Project	IEEE 802.16 Broadband Wireless Access Working Group < http://ieee802.org/16 >
Title	Missing definitions for CINR in OFDMA PHY
Date Submitted	2004-11-11
Source(s)	Intel. Yuval Lomnitz Yuval.Lomnitz@intel.com
Re:	IEEE P802.16REVd/D5-2004
Abstract	Add missing definitions of CINR in OFDMA
Purpose	Adopt changes
Notice	This document has been prepared to assist IEEE 802.16. It is offered as a basis for discussion and is not binding on the contributing individual(s) or organization(s). The material in this document is subject to change in form and content after further study. The contributor(s) reserve(s) the right to add, amend or withdraw material contained herein.
Release	The contributor grants a free, irrevocable license to the IEEE to incorporate material contained in this contribution, and any modifications thereof, in the creation of an IEEE Standards publication; to copyright in the IEEE's name any IEEE Standards publication even though it may include portions of this contribution; and at the IEEE's sole discretion to permit others to reproduce in whole or in part the resulting IEEE Standards publication. The contributor also acknowledges and accepts that this contribution

The following plot shows the performance of this scheme

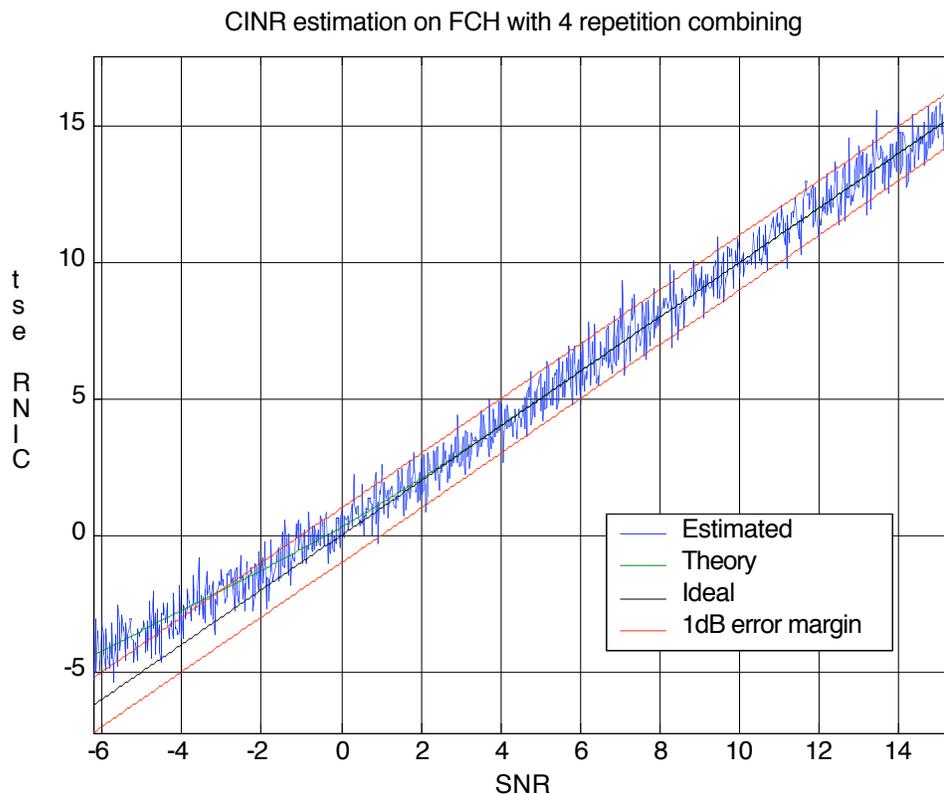
The distortion starts affecting the estimation at around 6dB SNR (0.3dB offset @ 6dB). Therefore by combining the 4 repetitions of the FCH, the distortion will start at 0dB SNR. Another advantage of using the repetitions is that the noise distribution becomes similar to Gaussian. After combining the repetitions we are left with 48 tones which include 96 BPSK samples, on which CINR can be estimated by hard slicing.

The standard deviation of the results is approximately 0.64dB over the entire scale, which guarantees 1dB accuracy with probability 95%.
